# Monroe Drive / Boulevard Complete Streets: Improvement Opportunities

## Decatur Street to Woodward Ave

### Preliminary Design Concepts

#### Boulevard between Carroll Street to Decatur Street Sidewalk Extension

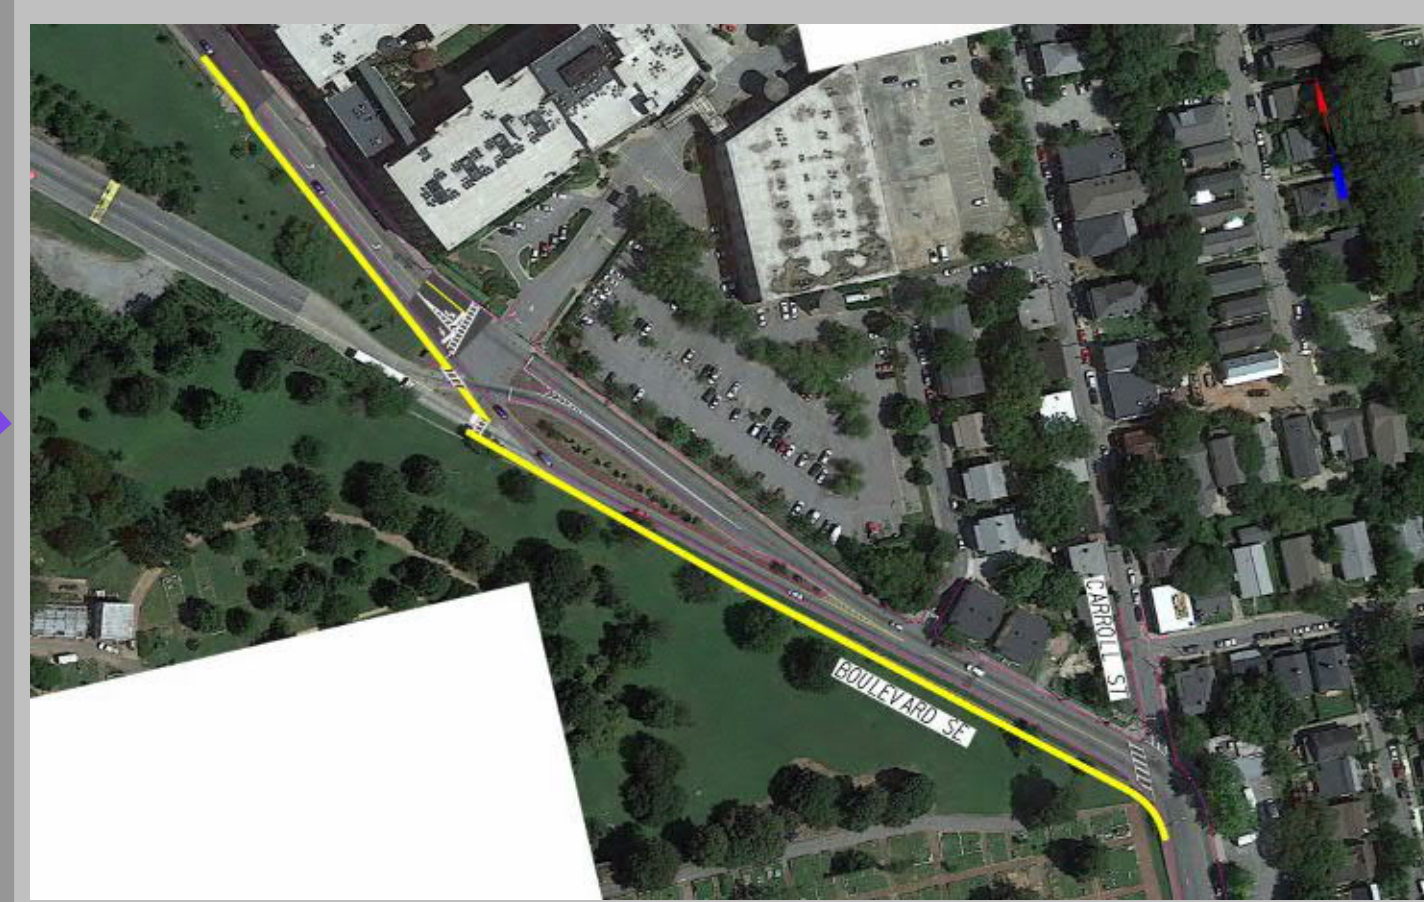
- Northeast side of Oakland Cemetery needs a sidewalk continuing up to the Boulevard tunnel (Public Comment)
- Continue sidewalk on south side of DeKalb Avenue crossing Boulevard (Transit Oriented Atlanta)
- Add a sidewalk along the northeast wall of the cemetery (west side of Boulevard), connecting the existing sidewalk that ends at Carroll St. with the CSX underpass and stairwell (Boulevard Road Safety Audit)

- Fills sidewalk gap between Oakland Cemetery and Decatur Street bridge

- Enhanced pedestrian safety through decreased crossing distances and minimized crossings at unsignalized locations\*

- No impact to vehicle travel times or delay

- Plausible within existing right-of-way

#### Boulevard at Carroll Street Pedestrian Crossing and Upgrade Flashing Beacons

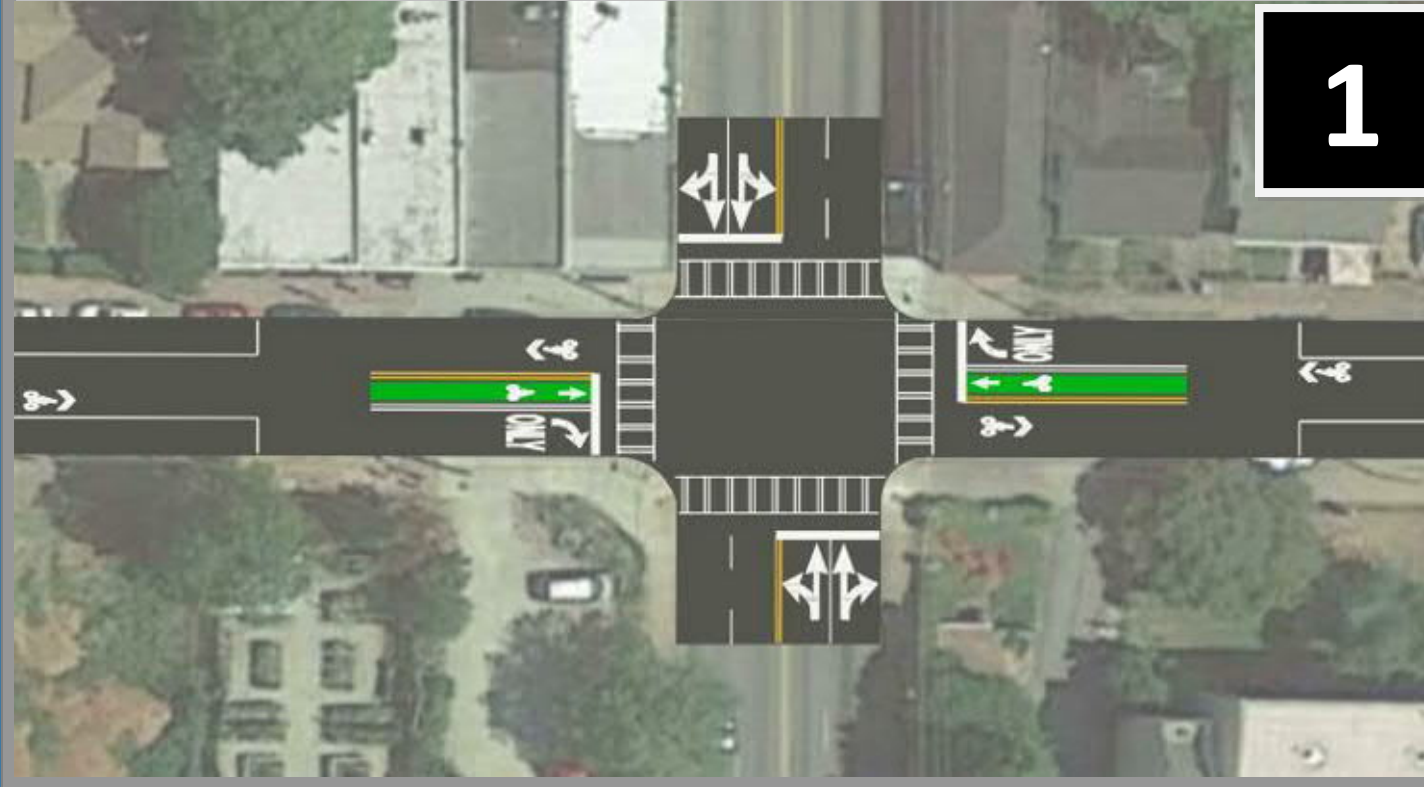
- Install crosswalk lights to help vehicles notice pedestrians at crossings (Public Comment)
- Create safer pedestrian crossings (Public Comment)
- Improve the pedestrian crossing at the intersection of Boulevard and Carroll Street (Public Comment)
- Traffic signal/RRFB at Carroll Street and Boulevard (Transit Oriented Atlanta)
- The Boulevard Road Safety Audit recommends that the existing crosswalk be moved approximately 100 feet to the southeast, where visibility is improved (Boulevard Road Safety Audit Report)

- Larger refuge on west side of Boulevard
- Increased visibility at crossing

- Enhanced pedestrian safety due to increased visibility
- Potential to reduce angle collisions by 5%\*\*

- No impacts to vehicle travel times and delays

- Plausible within existing right-of-way
